T-10415

PERMIT
AMENDMENT

Reference: Permit Amendment Transfer 10415

In the Matter of Permit Amendment	)	FINAL ORDER
T-10415, Curry County	)	APPROVING ADDITIONAL POINTS
	)	OF APPROPRIATION AND A
		CHANGE IN PLACE OF USE

Permit Amendment

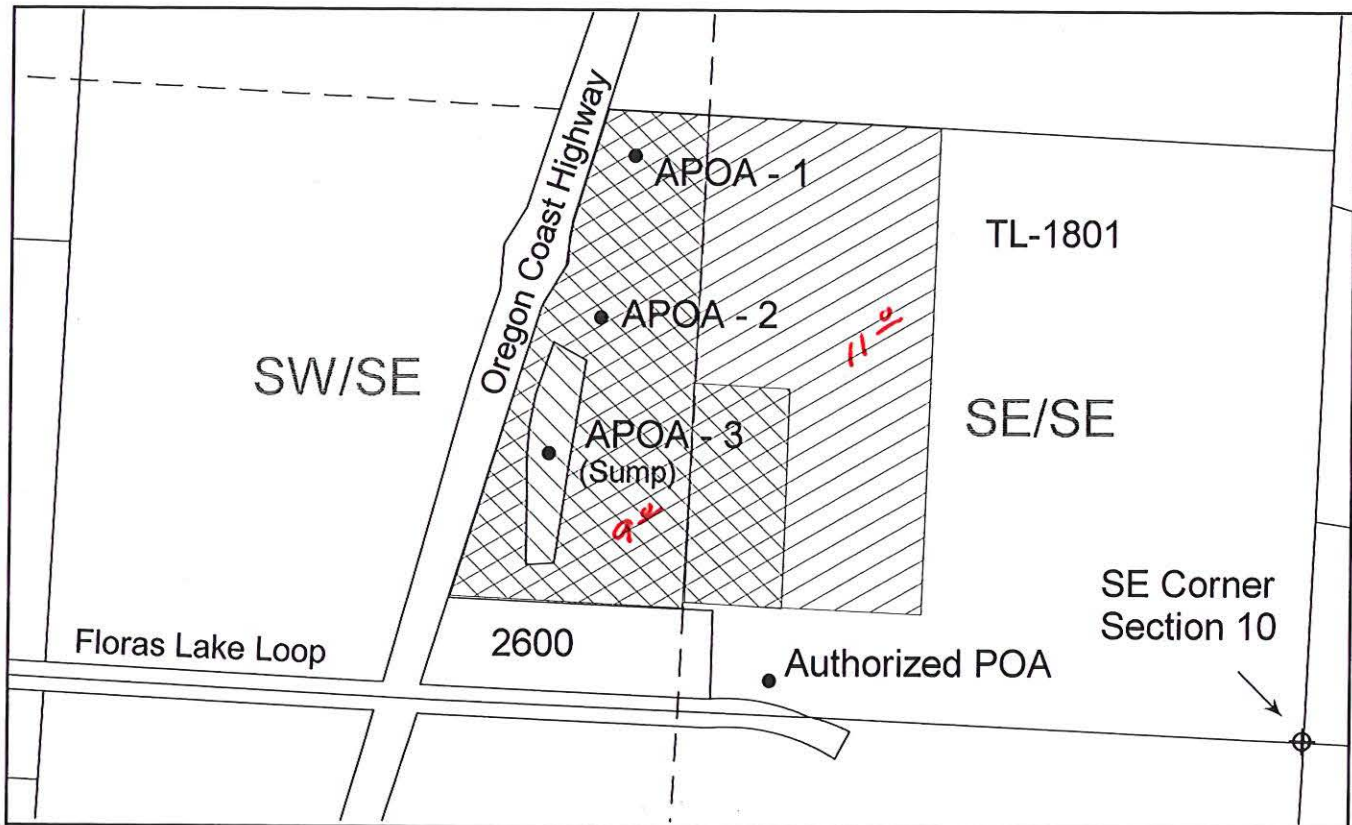
The proposed sump (well 3) and change (correction) in place of use pose no issues and can be approved once Wells 1 and 2 are re-located or dropped from the application.

7. On January 23, 2008, the applicant amended the permit amendment application to re-locate Wells 1 and 2 more than one-quarter mile from surface water sources.
8. The change, as amended, would not result in injury to other water rights.
9. The proposed place of use is owned by the permit holder.
10. The change does not enlarge the permit.
11. The change does not alter any other terms of the permit.
12. The proposed place of use is contiguous to the authorized place of use.

TO: File T-10415, Robert Donaldson
FROM: Donn Miller, Hydrogeologist
SUBJECT: Permit Amendment Comments

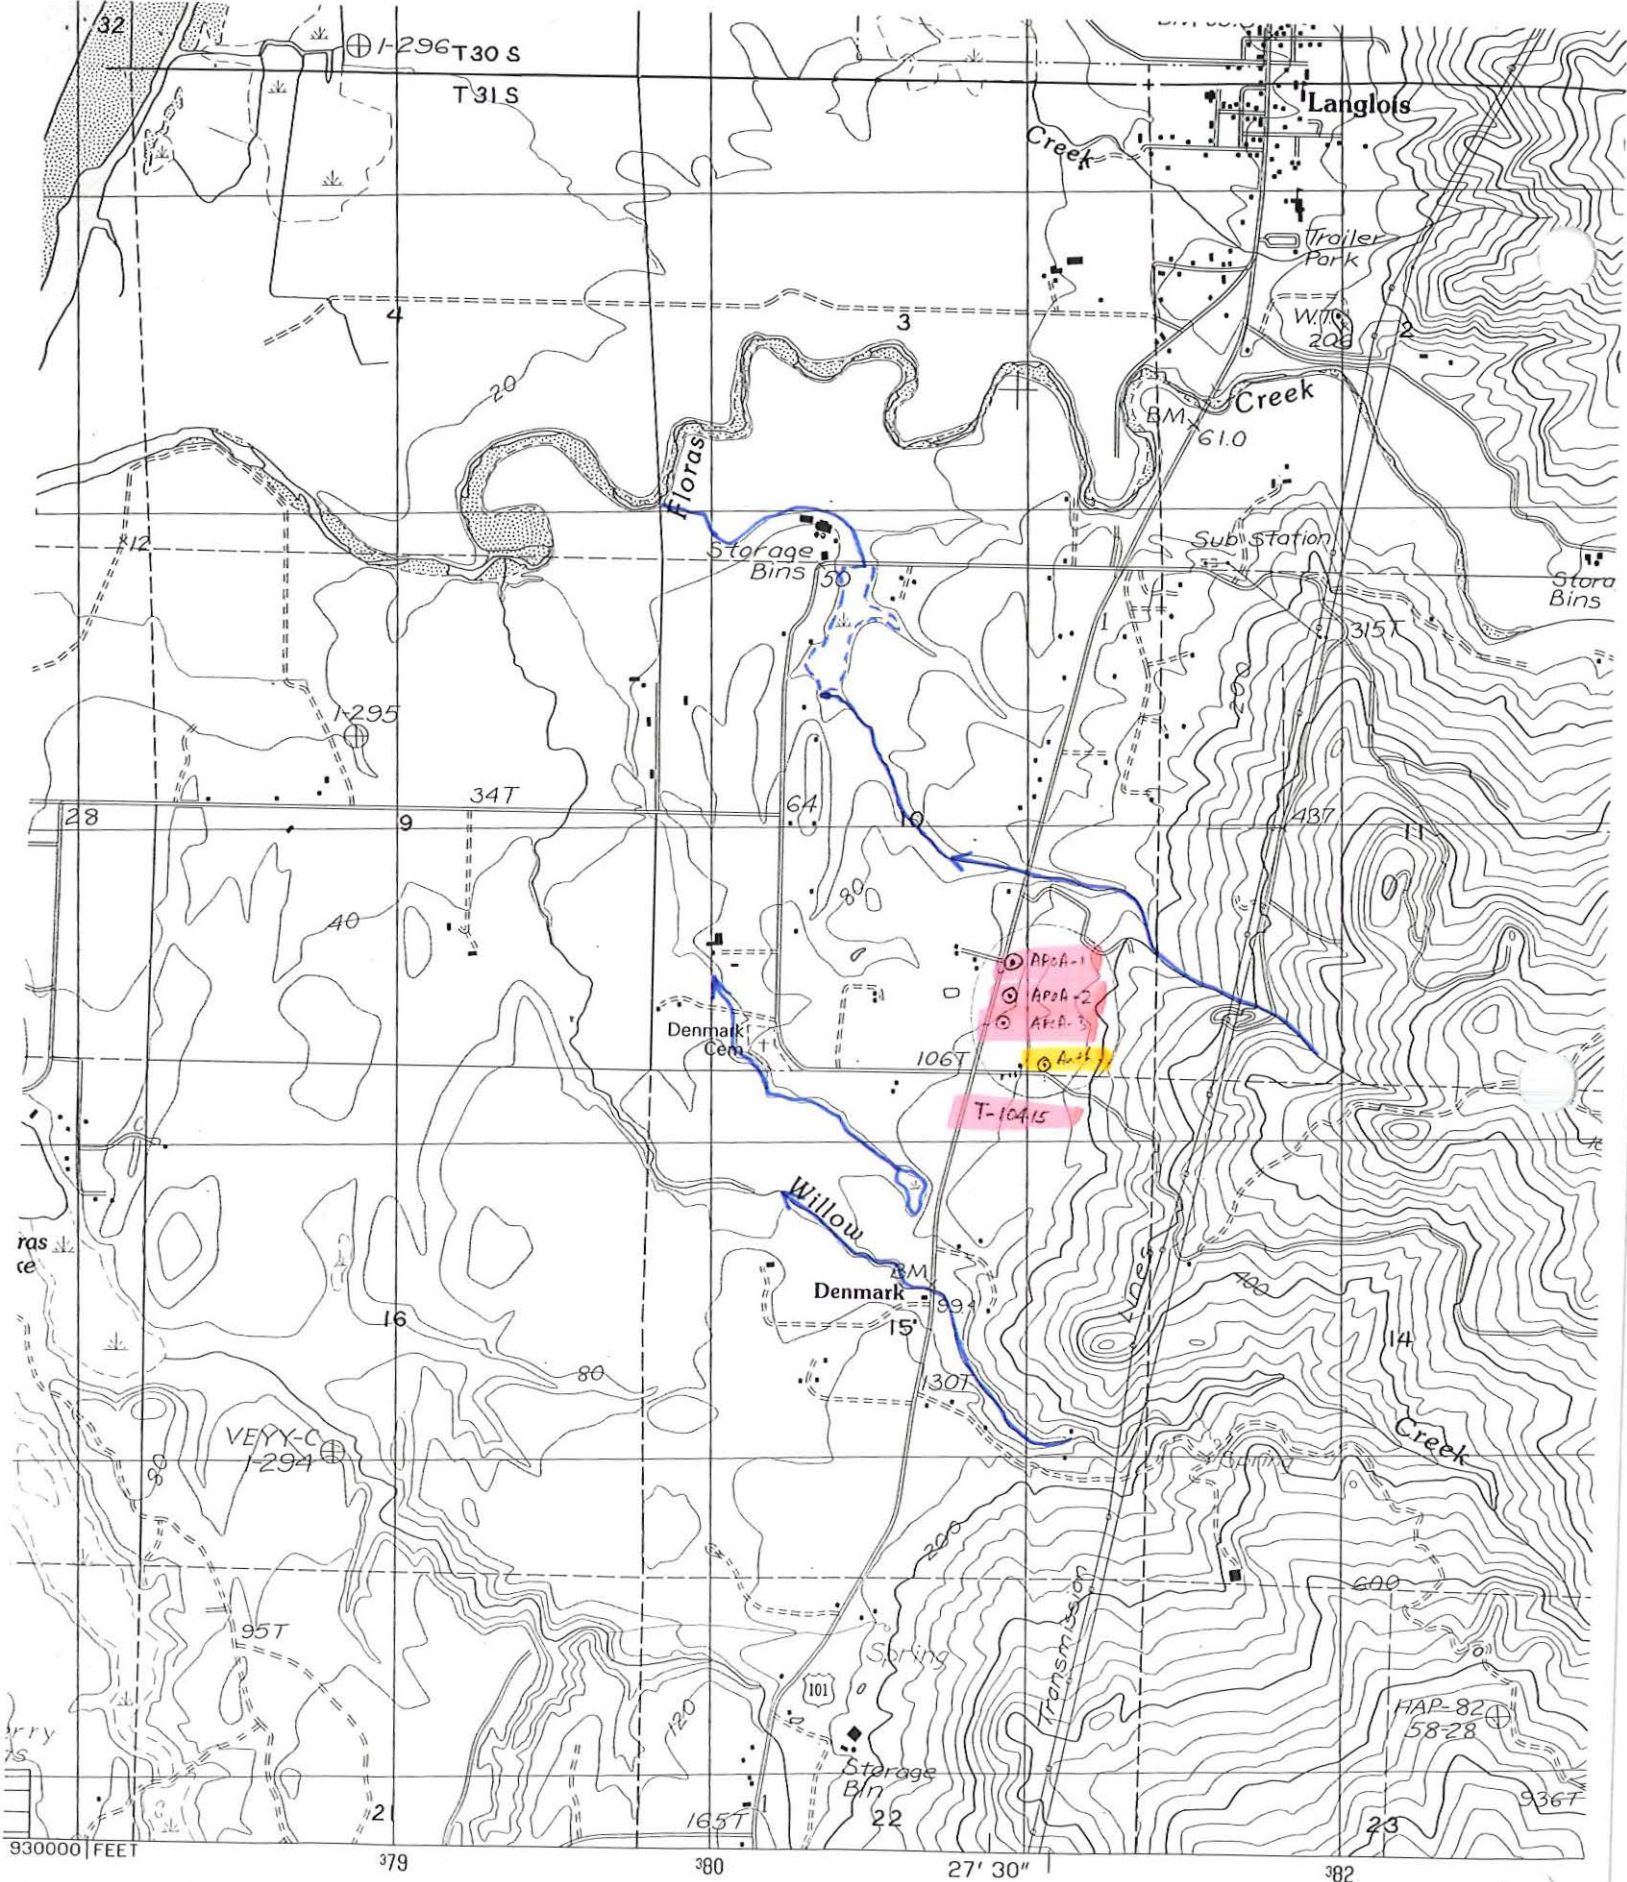
I have reviewed the base file (G-14685) and the permit amendment materials. The amendment proposes to add three additional points of appropriation (APOA) and change the place of use (POU). Only the matter of points of appropriation is germane to this ground water review. I don't see any problem with the POU change.

The existing, authorized POA is a sump. The proposed APOA's consist of a sump (APOA-3) and two wells (APOA-1 and APOA-2). Based on the locations and the proposed constructions of the shallow sump and wells, I conclude that the four POA's would develop the same unconfined aquifer source.

The original application was reviewed for ground water considerations in a 3/13/98 review by Doug Woodcock. Among other things, that review observed that the aquifer was unconfined and that the potential for substantial interference was low. Review methodologies in 1998 were somewhat different than they are today but the rules have not changed. In any case, the application did not have the potential for substantial interference per Division 9 rules and the permit was issued.

The APOA's pose new considerations for the evaluation of the potential for substantial interference under Division 9. APOA-3 is 1600' from an unnamed tributary of Floras Creek to the north. It does not have the potential for substantial interference. In my opinion, the proposed change for APOA-3 may be made without injury to an existing water right.

However, APOA-1 and APOA-2 are 900' and 1300' from that same tributary and have the potential for substantial interference. This poses a problem with authorizing a permit amendment to add those APOA's since the water availability tables show that the in-stream water right on Floras creek is not satisfied during nine months of the year. The right is satisfied and water is available only for December, February, and March. With this information, in my opinion the proposed changes for APOA-1 and APOA-2 will result in injury to an existing water right (IS 70891).
